Process Sheet

Customer : CU-DAR001 Dart Helicopters Services
Job Number : 24865
Estimate Number : 10467
P.O. Number : N/A
This Issue : 11/24/2005 S.O. No. : N/A
Prsht Rev. : NC
First Issue : N/A Type : MACHINED PARTS
Previous Run : 24865

Drawing Name : FWD TUBE ASSEMBLY
Part Number : D3391021
Drawing Number : D3391 REV B AH
Project Number : N/A Rev D 06.03.28
Drawing Revision : B
Material : N/A
Due Date : 12/20/2005 Qty: 5 Um: Each

From: "Peter Hum" <phum@dartaero.com>
To: "David Shepherd (E-mail)" <davids@dartaero.com>
Sent: Thursday, January 05, 2006 12:13 PM
Subject: D412-742 fwd tube tolerance change

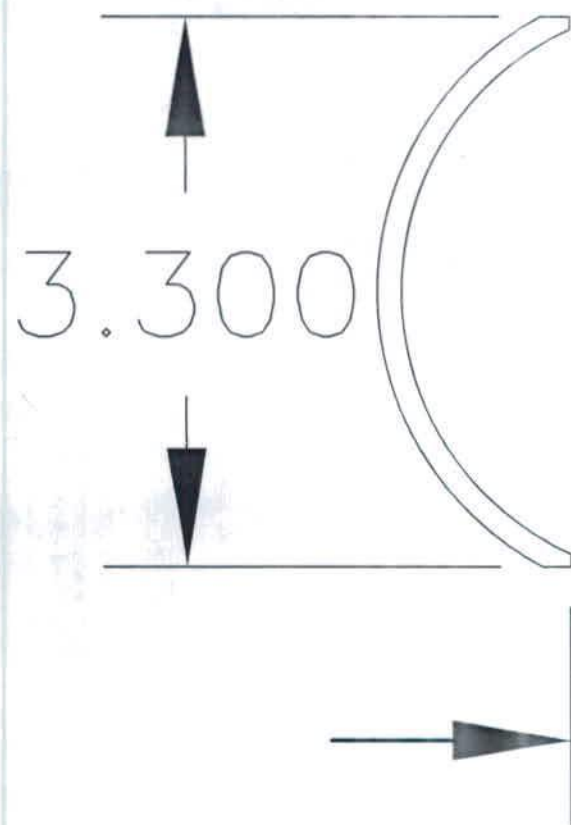
> Hi David,
>
> Is it acceptable to change the tolerance of the large slot that
> accommodates the I-beam in the fwd tube to (+0.000,-0.030)? If the
> dimension is at the lower limit, this will in fact strengthen the part.
>
> I've attached a sketch to show which dimension is changing
>
> Peter Hum
> Mechanical Designer
>
> DART Aerospace Ltd.
> Email...phum@dartaero.com
> Phone...613-632-3336
> Fax.....613-632-4443
>
>

This is an acceptable deviation.

From: "Peter Hum" <phum@dartaero.com>
To: "David Shepherd (E-mail)" <davids@dartaero.com>
Sent: Tuesday, January 17, 2006 1:04 PM
Subject: D3391-1 FWD TUBE DEVIATIONS

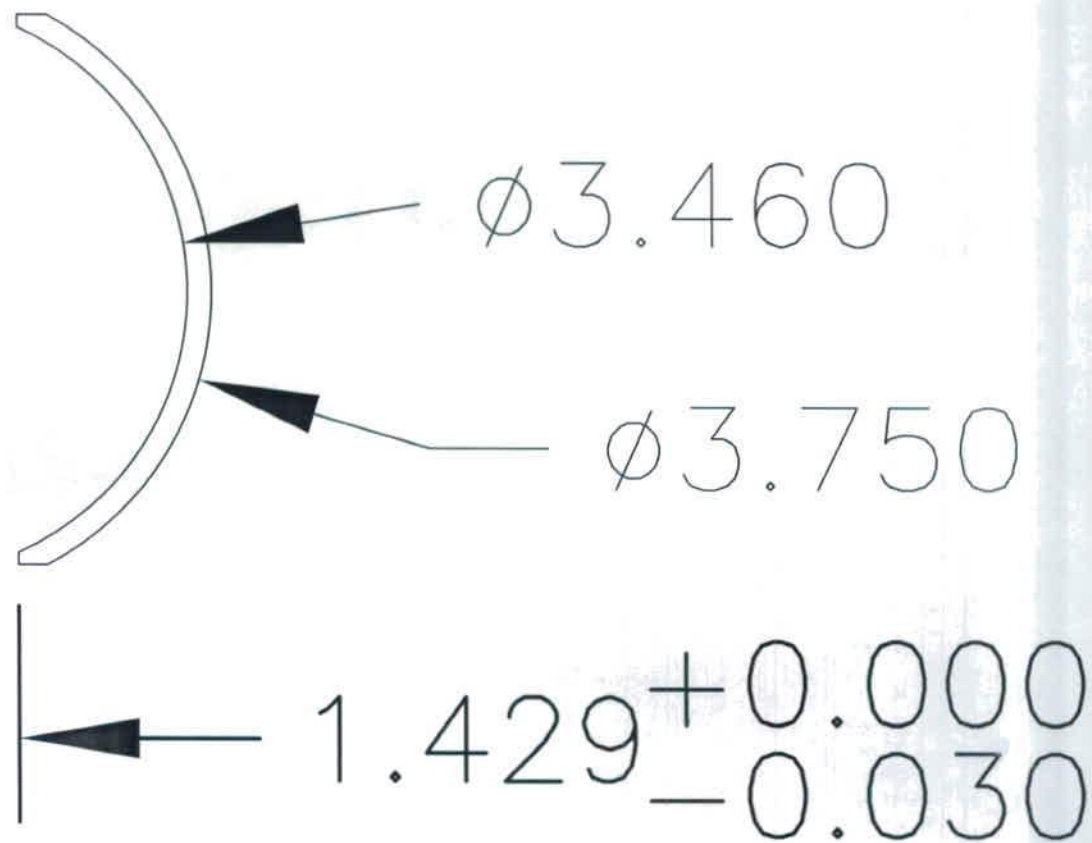
> David,
>
> In manufacturing the fwd tube, there have been tubes that are out of
> tolerance. The dimension 3.580" is actually 3.595" and the 1.429"
dimension
> is 1.390" as shown in the attached sketch. The tolerance of the 1.429"
> dimension was previously changed to (+0.000,-0.030). In both dimensions,
the
> end result is more material. Are these deviations acceptable?
>
> Peter Hum
> Mechanical Designer
>
> DART Aerospace Ltd.
> Email...phum@dartaero.com
> Phone...613-632-3336
> Fax.....613-632-4443
>
>

Assuming that this part fits with the middle tube it mates with, the deviations listed below are acceptable.
